## TECHNICAL MEMORANDUM

**Date:** August 19, 2020  
**To:** Emily Anderson, Alaska Program Director, Wild Salmon Center  
**From:** André Sobolewski, Clear Coast Consulting, Inc  
**Subject:** Review of water treatment plants proposed in FEIS for Pebble Project

**Figure 1. Water Treatment Plant #2 - Operations Phase. Taken from USACoE FEIS Appendix N – Project Description**

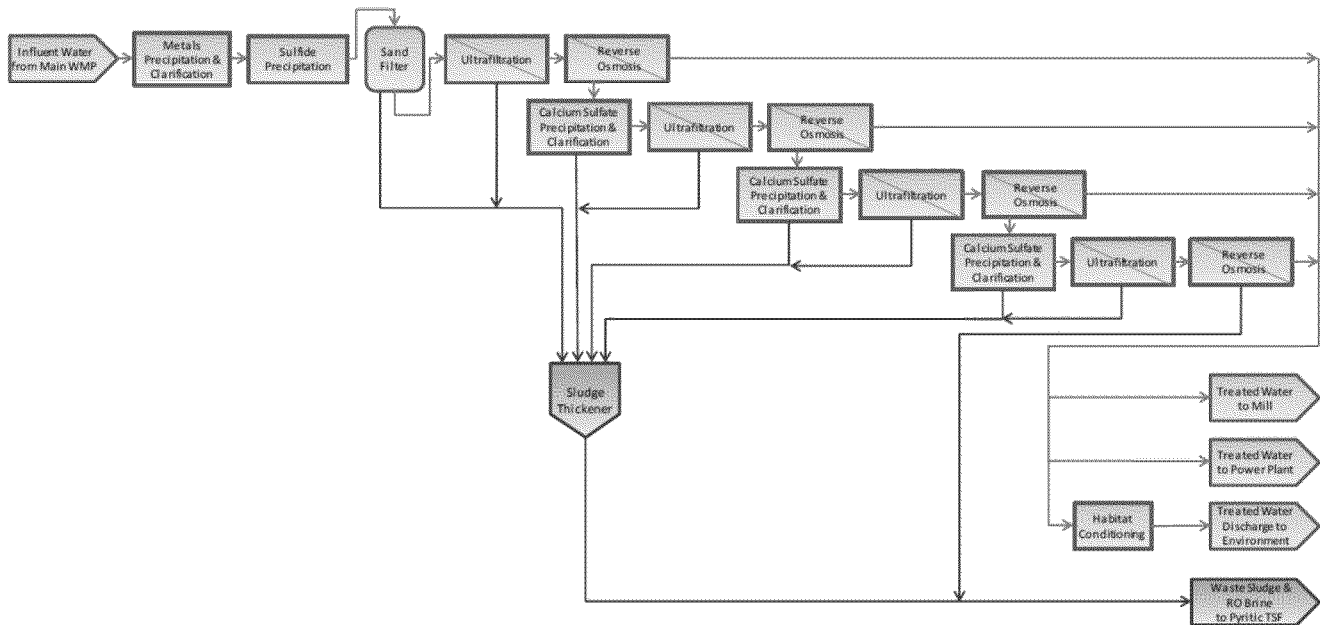
For this analysis, I used the proposed WTP #2 for mine operations (Figure 1), as it is among the most comprehensive WTP proposed for this project (WTP #3 also comprises an evaporator/crystallizer unit). This treatment system shares many components with WTP #1 and WTP #3 and any analysis of WTP #2 will readily apply to these other treatment plants.

The first step in the treatment process – permanganate oxidation and ferrihydrite precipitation – is effective in removing arsenic and manganese and is widely used. Depending on treatment conditions (pH, ORP), molybdenum will also be removed to acceptable levels, as evident by the treatment plant at the closed Brenda Mine (Aubé and Stroiazzo, 2000) and at Codelco's El Teniente Mine (Aubé and Vergara, 2010).

Permanganate oxidation, followed by ferrihydrite precipitation is reported to remove selenium (RFI 021e Addendum, 2019), but this is incorrect. Ferrihydrite precipitate the *partially-reduced* selenite ( $\text{SeO}_3^{2-}$ ), not the *full oxidized* selenate ( $\text{SeO}_4^{2-}$ ). Thus, an initial reductive step is required to reduce the unreactive selenate to selenite, like the addition of zinc dust (Alberta Environment, 2005), and to remove it via iron co-precipitation. The latter reaction is effective in decreasing high inflow concentrations of selenium, but it can only decrease its levels to  $\sim 0.020$  mg/L. An additional step is necessary to decrease its concentration  $< 0.005$  mg/L.

Iron co-precipitation can remove several metals; however, their concentrations will not be decreased low enough to meet stringent water quality criteria (MEND, 2014). A High-Density Sludge (HDS) system is required to decrease metals to trace levels, but this is not what is proposed at Pebble. Therefore, additional treatment will be required to decrease the concentration of most metals to levels acceptable for discharge.

Selenium is proposed to be removed as a selenide via precipitation with sulfide. This reaction is technically possible and has been demonstrated in the laboratory, but it requires conditions that are not met in a mining environment (low redox potential, high sulfide concentrations, etc). To my knowledge, this process has never been used in a commercial application, and certainly never at a large-scale mining operation. Several specialists who know or investigated this process<sup>1</sup> have confirmed that it is impractical for selenium removal from mine water.

In the absence of chemical precipitation, selenium will be removed in the WTP by membrane filtration, either via nanofiltration or reverse osmosis. Given that selenium-containing brine generated by membrane filtration will be discharged into the Pyritic TSF, there is a concern that its concentration will build up in mine water because WTP #2 → Brine → Pyritic TSF → Main WMP → WTP #2 is a closed-loop circuit. This concern was acknowledged by Pebble and was analyzed through a water balance and water chemistry model (Knight Piésold, 2019). I reviewed this model.
